Service Bulletin

SUBJECT: Service Update for Inventory and Customer Vehicles
Excessive Wiring Harness Length
Expires with Base Warranty

MODELS: 2015 Chevrolet Colorado
2015 GMC Canyon
Equipped with 3.6L V6 Engine (RPO LFX)

This bulletin is being revised to update Step 1 of the Repair Procedure in the Service Procedure section. Please discard all copies of bulletin 15671.

4355973

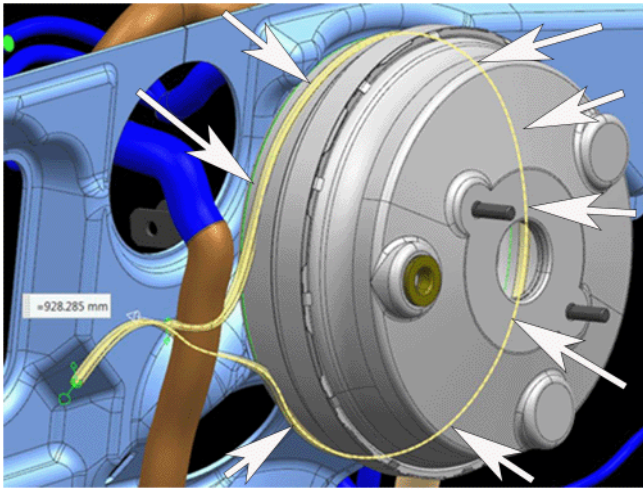
2. Measure the clearance between the threaded boss on the engine cylinder head and the wiring harness as shown (1).

- If the clearance (1) is 25mm (1.0 in.) or **more**, no further action is required.
- If the clearance (1) is **less** than 25mm (1.0 in.), proceed to the repair steps below.
